Peach Bottom Atomic Power Station, Units 2 and 3
Facility Operating License Nos. DPR-44 and DPR-56
NRC Docket Nos. 50-277 and 50-278

Subject: License Amendment Request
Activation of the Trip Outputs of the Oscillation Power Range Monitor
Portion of the Power Range Neutron Monitoring System

Figure 3.4.1-1 (page 1 of 1)
THERMAL POWER VERSUS CORE FLOW
STABILITY REGIONS

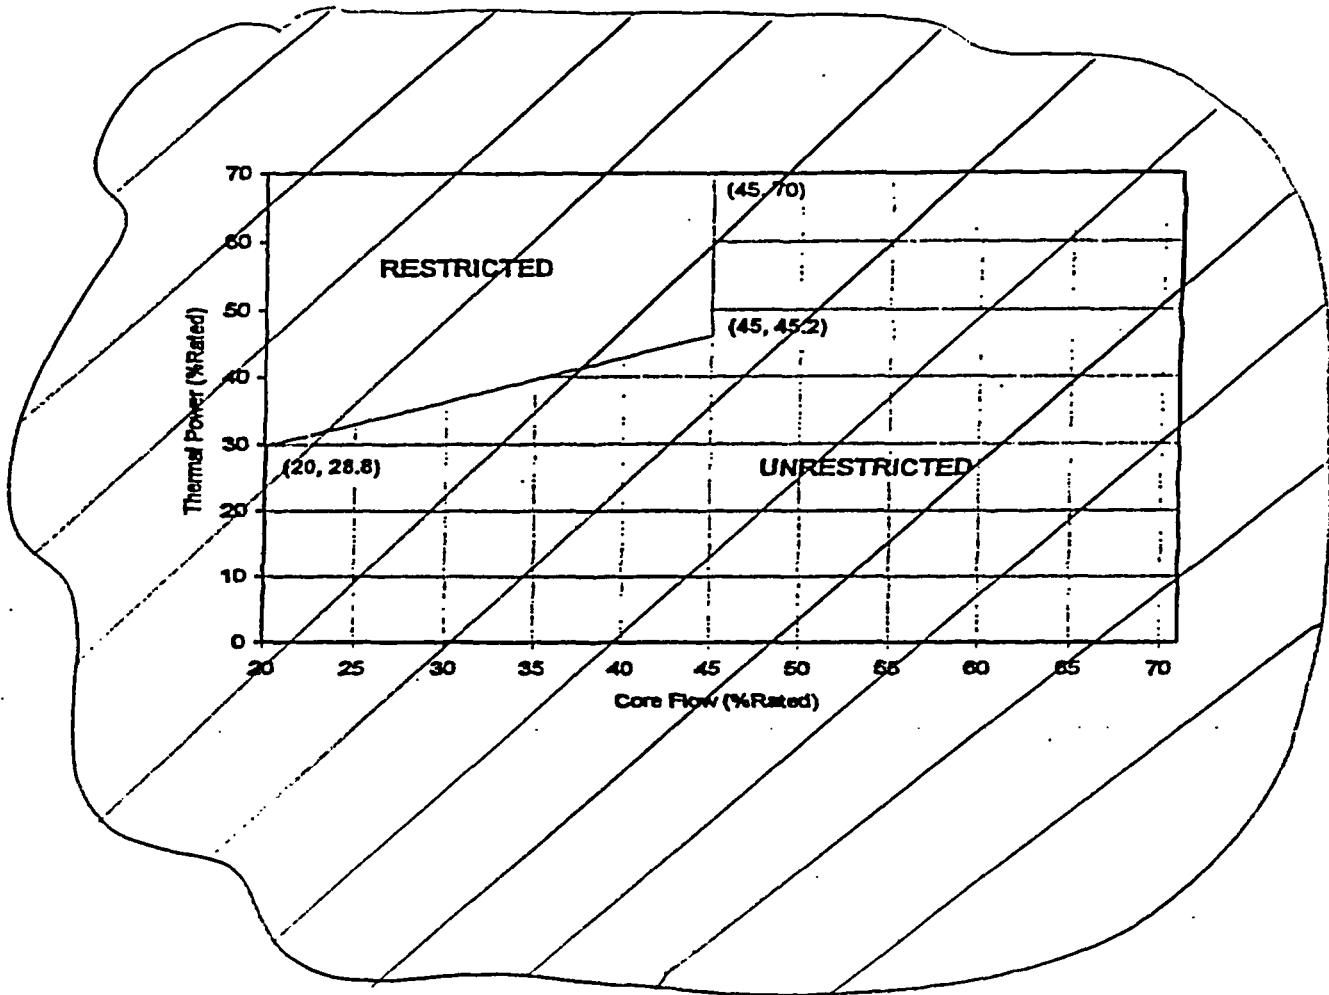
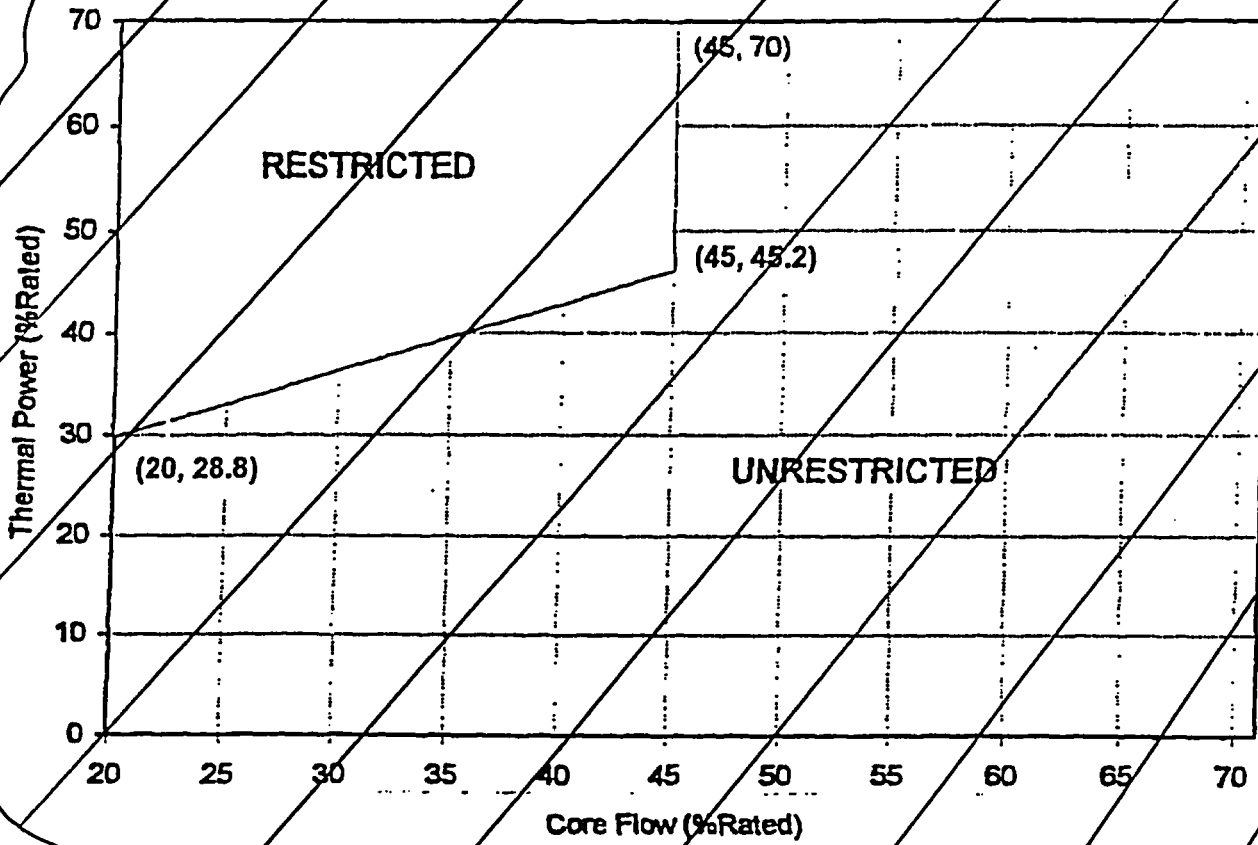
LCO restrictions on operating region (references to Figure 3.4.1-1) will be deleted from the LCO both for two loop and single loop operating conditions. Conditions A, B and C and their associated Required Actions, and Required Action F.1, each associated with operation in the Restricted Region and included previously as part of the ICA actions, will be deleted. These changes, along with deletion of the related Bases discussions, effectively delete the TS requirements for the ICAs. [Note: The NUMAC PRNM LTR does not address deletion of ICA related Technical Specifications. Therefore, all Specification 3.4.1 changes are beyond those covered by the NUMAC PRNM LTR.]
